April 1, 1986

RE: OSM Request, Chronology, Certification for Sedimentation Ponds, Star Point Mines, Plateau Mining Corporation, ACT/007/006, Carbon County, Utah

On August 20 and 21, 1985, an oversight inspection was conducted at Plateau Mining Company, Starpoint 1 and 2 Mines, permit #ACT-007-006. The inspection was conducted jointly with Barton Kale and Henry Austin representing our respective agencies. (Please refer to OSM Minesite Evaluation Inspection Report dated September 19, 1985.)

Figure 1. Stage capacity curve for Sediment Pond No. 3

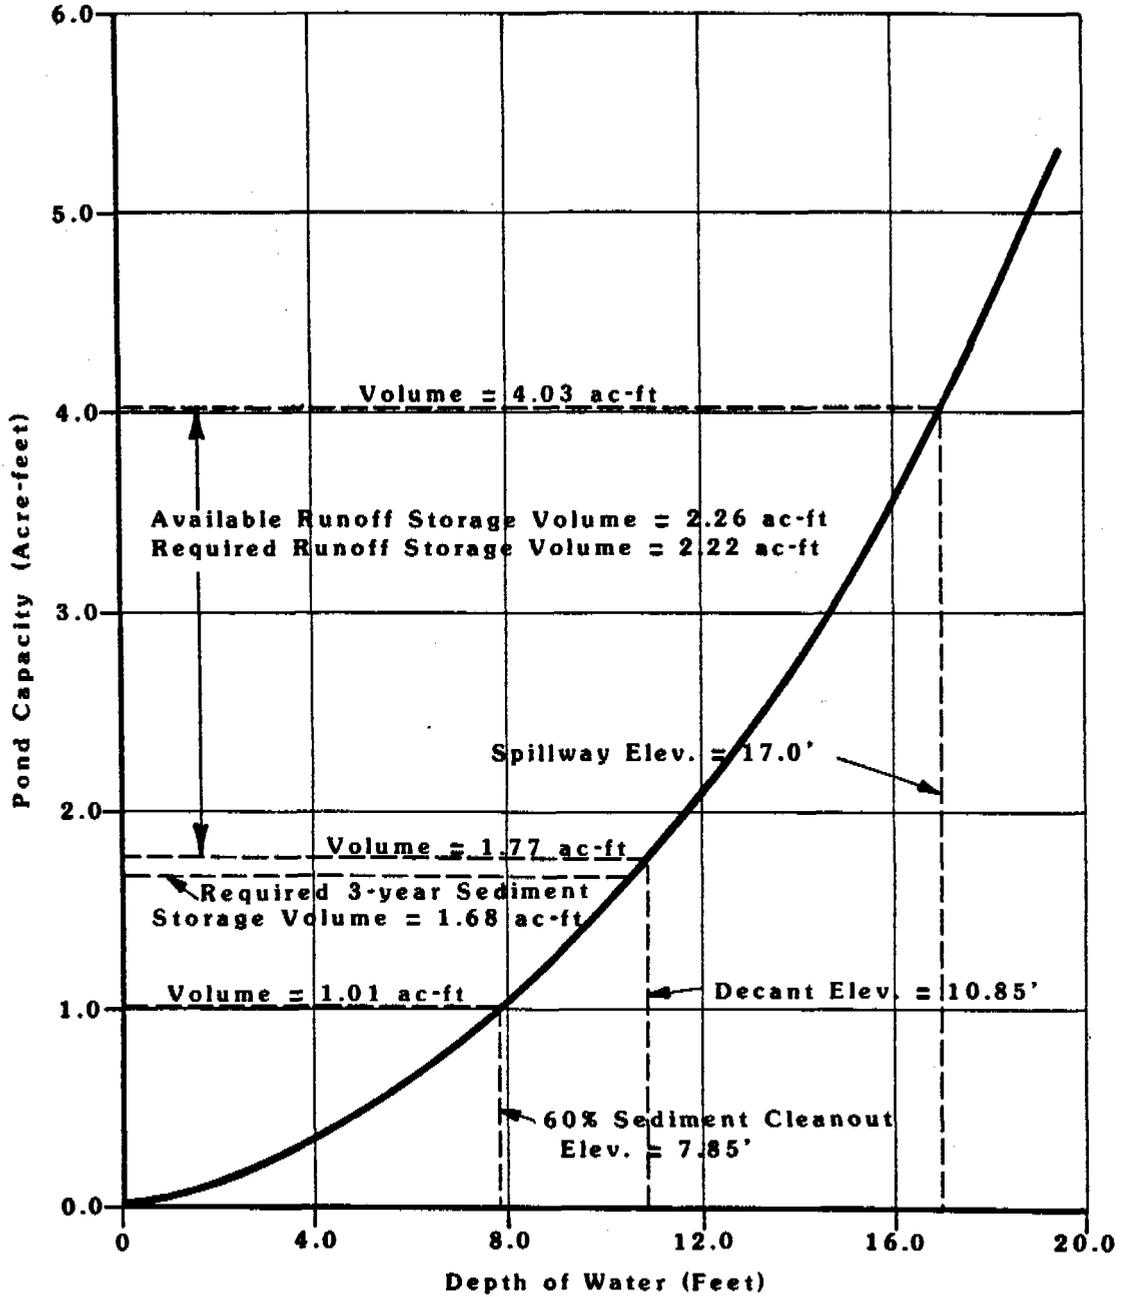
Runoff and sediment storage requirements for Sediment Ponds No.3 and No. 5 were summarized in a previous report prepared by Vaughn Hansen Associates (December, 1983), entitled "Review of As Built Runoff and Sedimentation Control Plan Star Point Mines, Plateau Mining Company." As indicated in the above referenced report, the three-year sediment storage requirements for Ponds No. 3 and No. 5 are 1.68 ac-ft and 2.24 ac-ft, respectively. The 10-year, 24-hour runoff volume storage requirements for Ponds No. 3 and No. 5 are 2.22 ac-ft and 4.28 ac-ft, respectively. As illustrated on Figures 1 and 2, both Ponds No. 3 and No. 5 are of adequate capacity to meet the above hydrologic design criteria. In addition to checking the pond capacity versus hydrologic design volume criteria, the ponds were visually inspected and appear to be in good condition.

Based on the information submitted the Division finds that pond 3 and pond 5 have adequate sediment and runoff storage capacity (see Vaughn Hansen Associates response), that the "as-built" survey of the ponds conducted and certified by Mr. Bruce T. S. Ware (a registered land surveyor) show that the designs of the constructed ponds closely approximate the approved plan; and that the stability analyses of ponds No. 3 and 5 conducted by R & M consultants show the existing embankments to be stable.

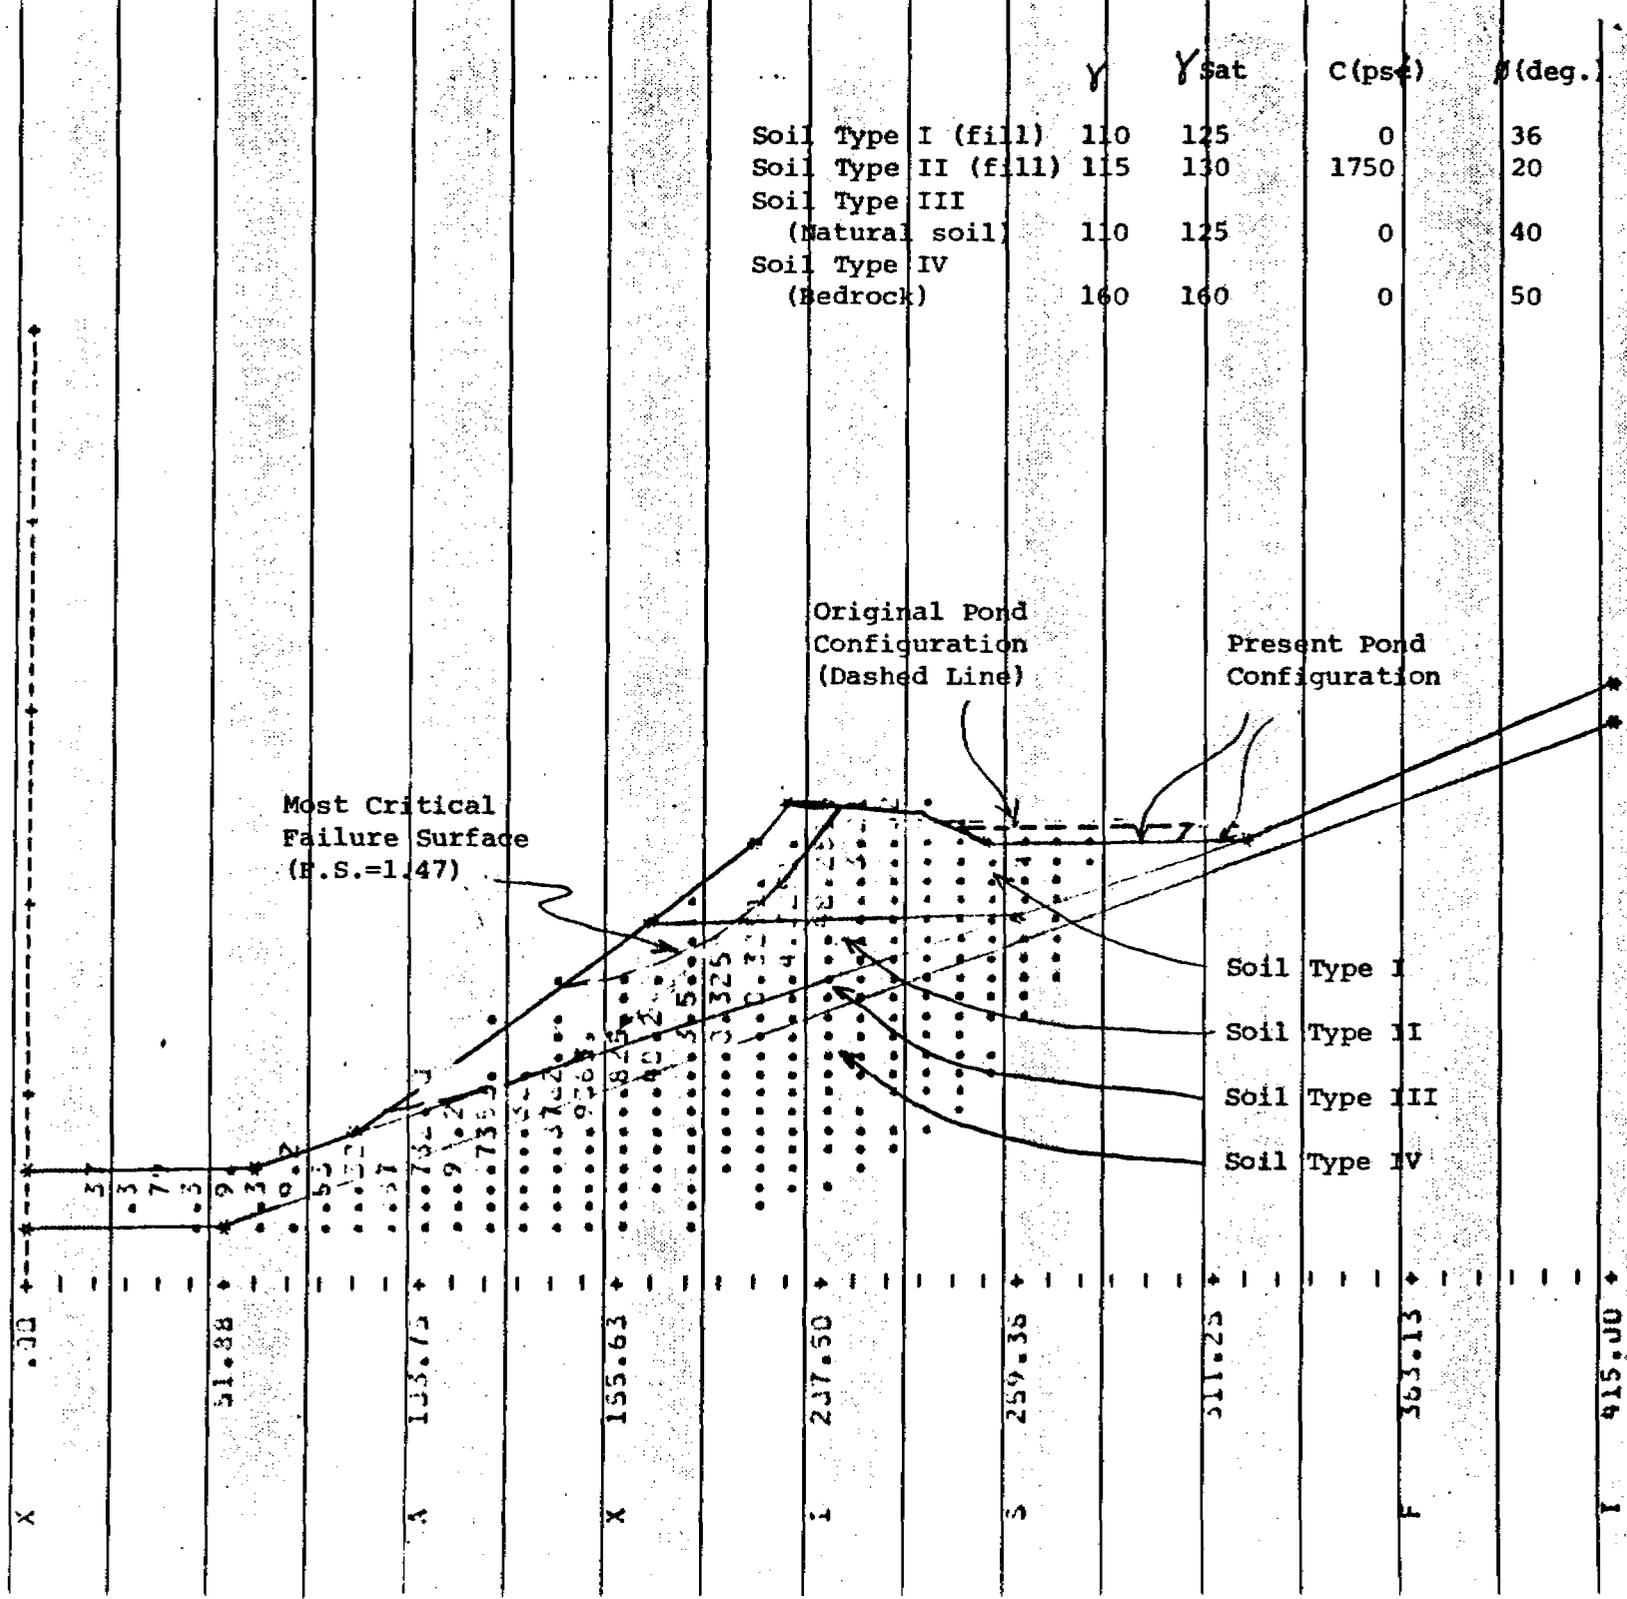
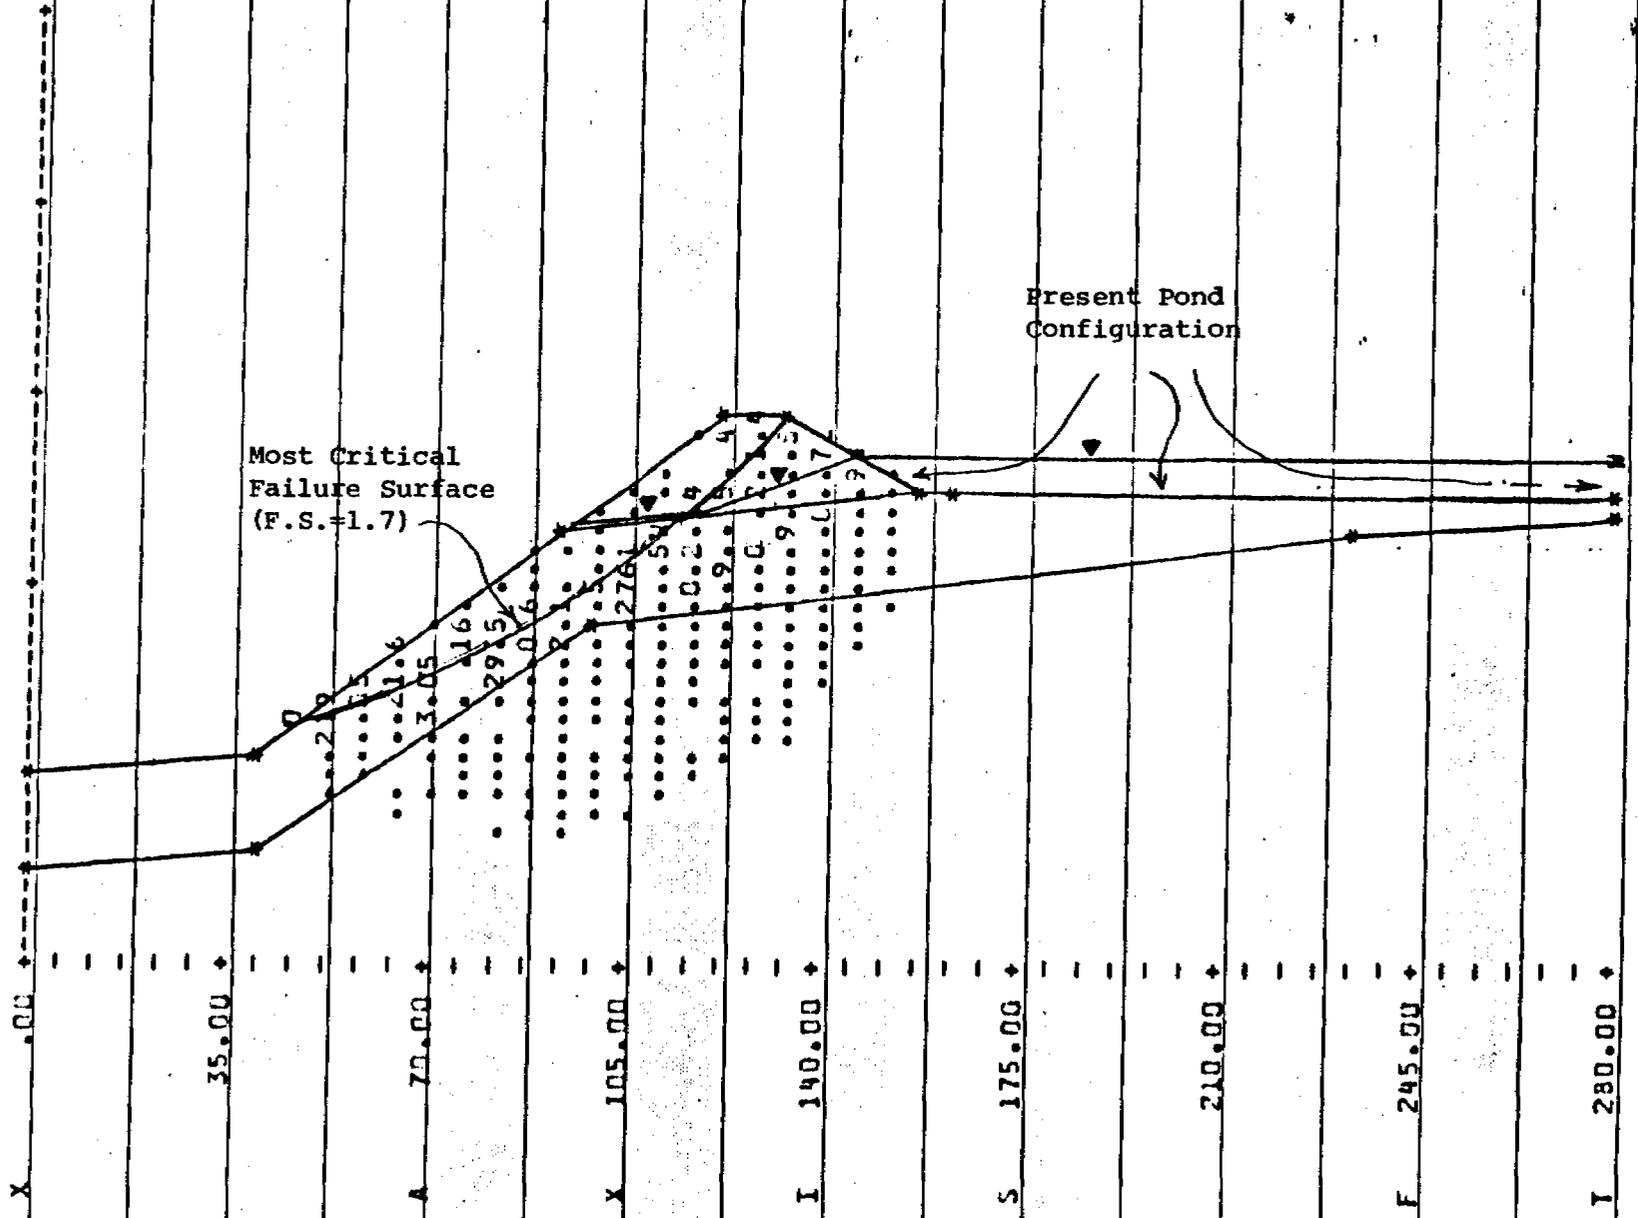
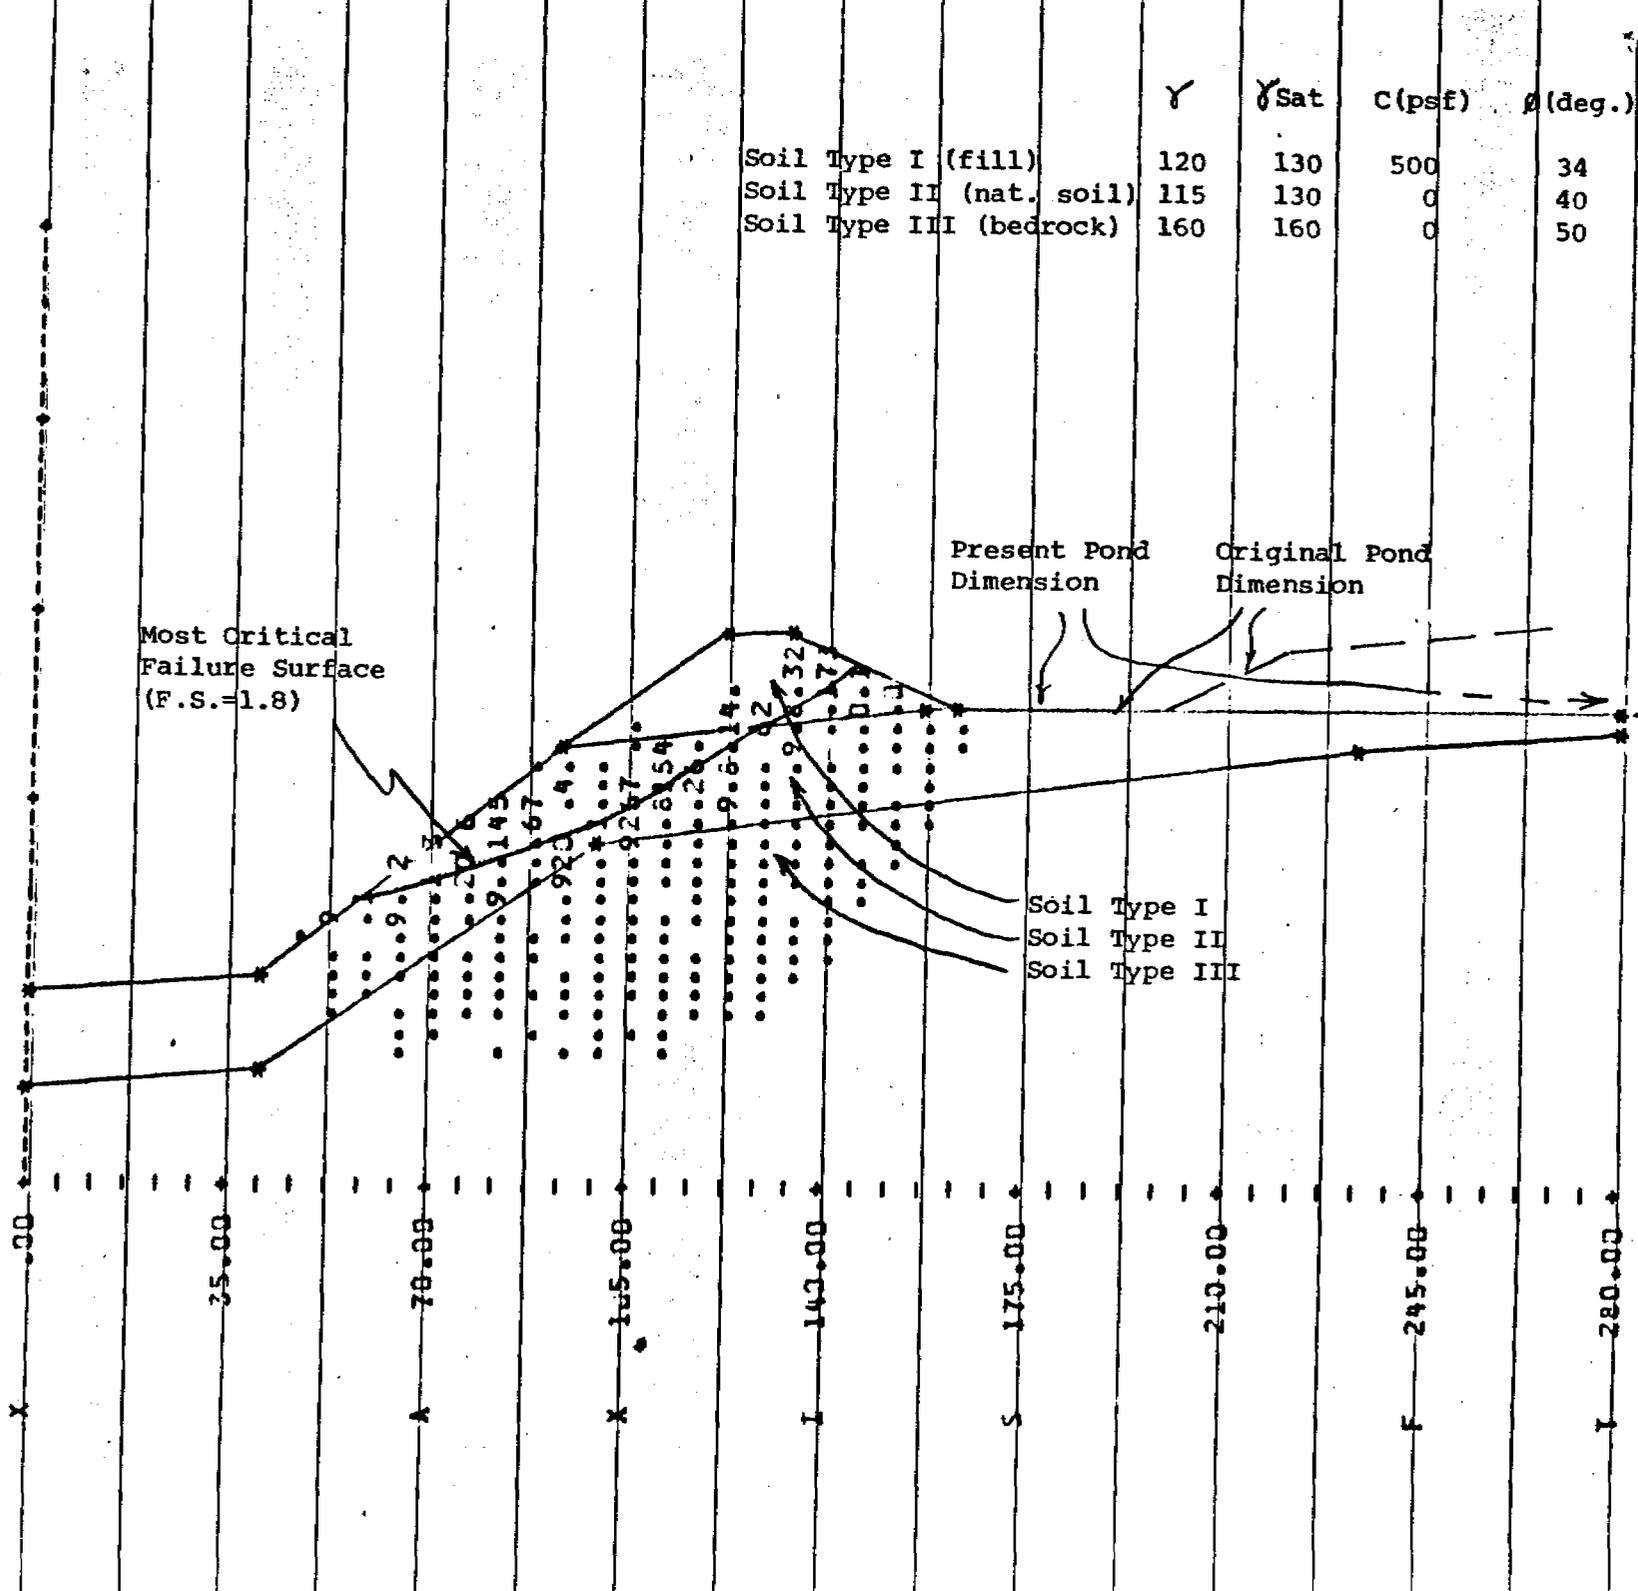
Copies of the graphical output of the STABL2 program are presented on the attached Drawing Nos. 1 through 4.
